UN GTR No. 6 (Safety Glazing)

Authorization to develop an amendment to UN Global Technical Regulation No. 6 (Safety Glazing)

Submitted by the representative from Republic of Korea*

Request for authorization to develop an amendment to global technical regulation No. 6 (Safety Glazing)

Figure 4
Determination of Zone 1

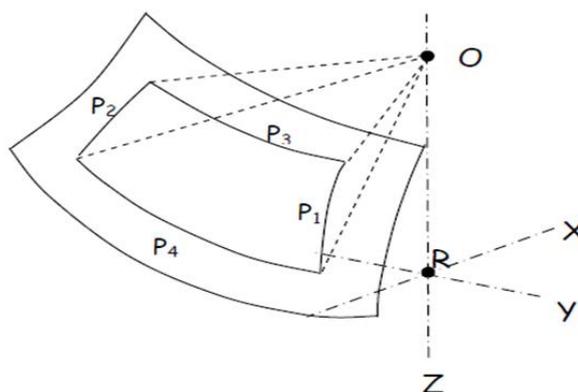
- (v) Para. 7.1.3.3.2. Zone I is the zone determined by the intersection of the windscreen with the four planes defined below:

In addition, opaque obscuration can be exempted in Zone I. It is the limited areas where it is intended that a sensing device, e.g. a rain-drop detector, rear view mirror or autonomous vehicle sensors, will be bonded to the inner side of the windscreen. The opaque obscuration where such devices may be applied is defined in paragraph 7.1.3.2.4.(Figure 2(a) or Figure 2(b)) of this annex.

P1 a vertical plane passing through O and forming an angle of 15° to the left of the median longitudinal plane of the vehicle;

P2 a vertical plane symmetrical to P1 about the median longitudinal plane of the vehicle.

If this is not possible (in the absence of a symmetrical median longitudinal plane, for instance) P2 shall be the plane symmetrical to P1 about the longitudinal plane of the vehicle passing through point O.

P3 a plane passing through a transverse horizontal line containing O and forming an angle of 10° above the horizontal plane;

P4 a plane passing through a transverse horizontal line containing O and forming an angle of 8° below the horizontal plane;
